RESPONSE TO CENTER FOR PUBLIC ENVIRONMENTAL OVERSIGHT

March 18, 2016

SUBJECT: Response to Center for Public Environmental Oversight (CPEO) Comments

CROSS SECTION X TO X'

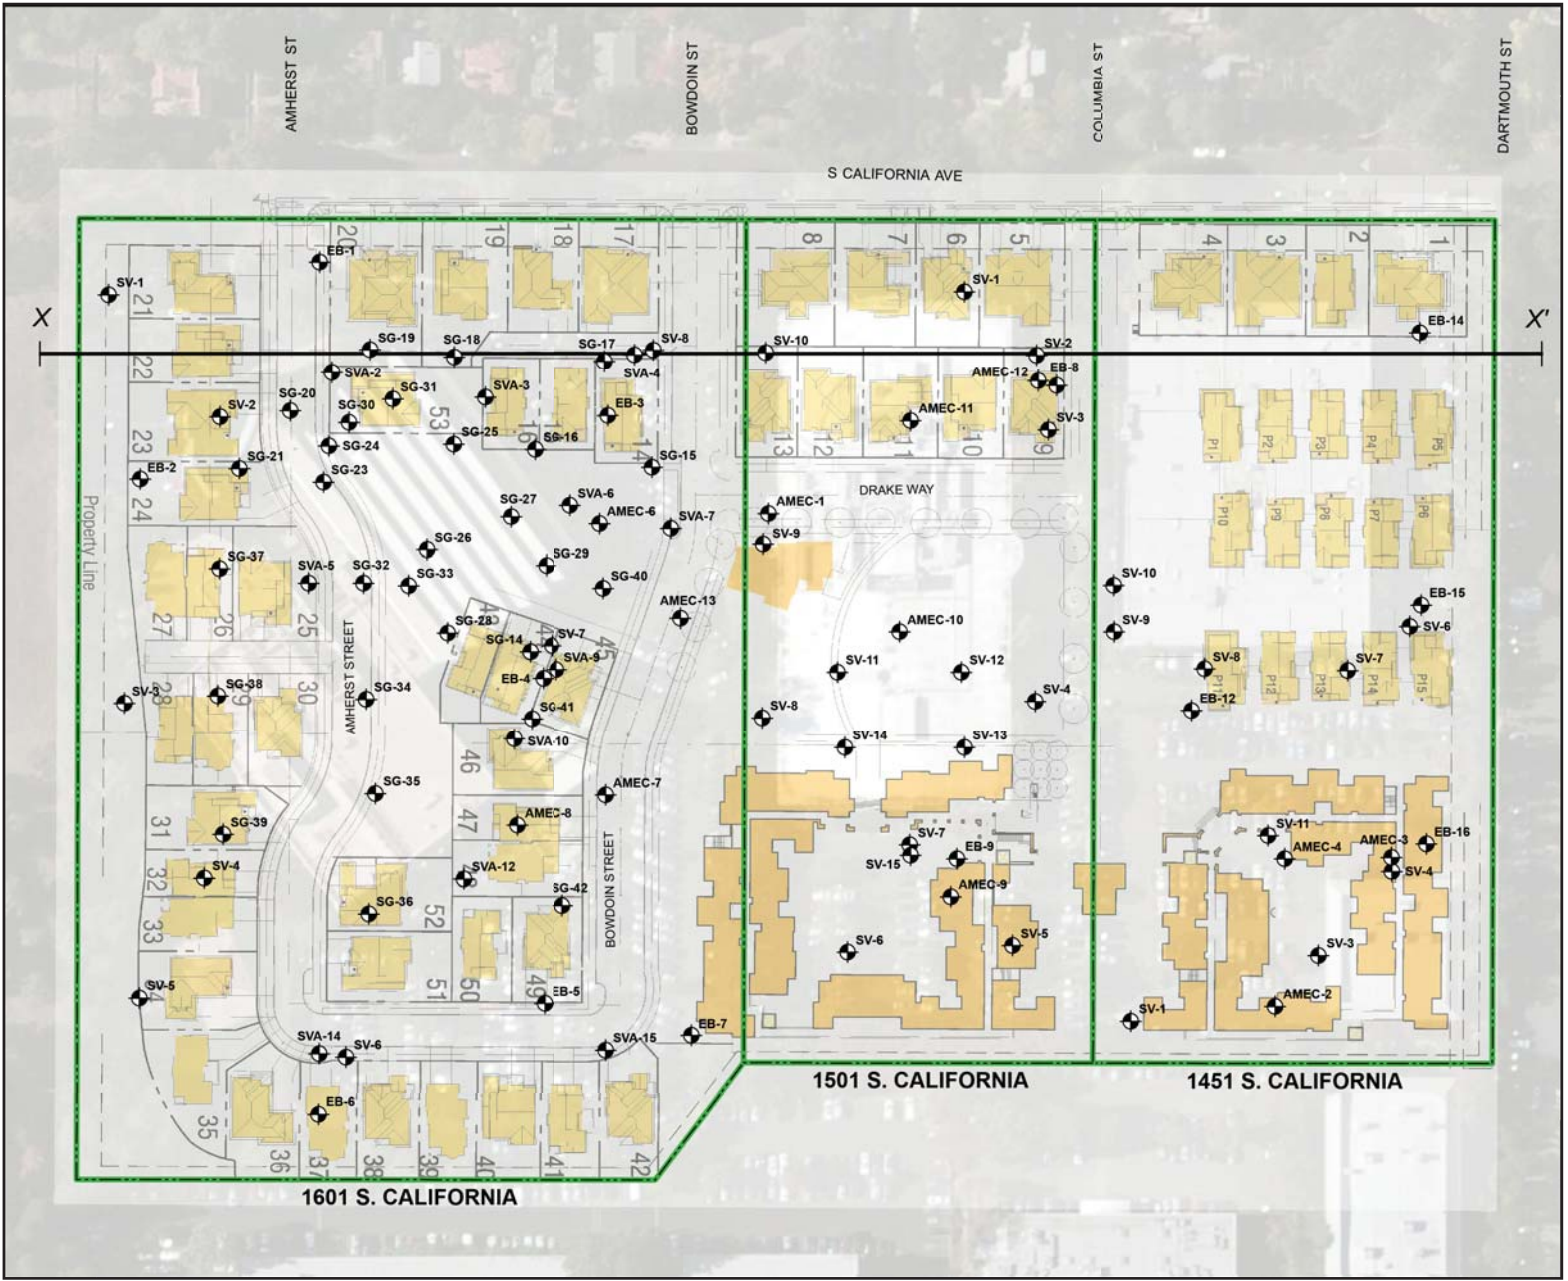
- The lithology (geologic units) of primarily fine-grained units along California Avenue inhibits migration of soil vapor. A cross-section parallel to California Avenue with concentrations of TCE measured in soil vapor is presented as Figure 2.
- The investigation data consistently indicate the absence of TCE above screening levels outside of the operational and nearby area on the 1601 S. California Avenue site.
- The release of TCE into the subsurface occurred at least several decades ago and all of the potential sources of TCE (e.g., plating solution sump) were removed during Site demolition. Ten
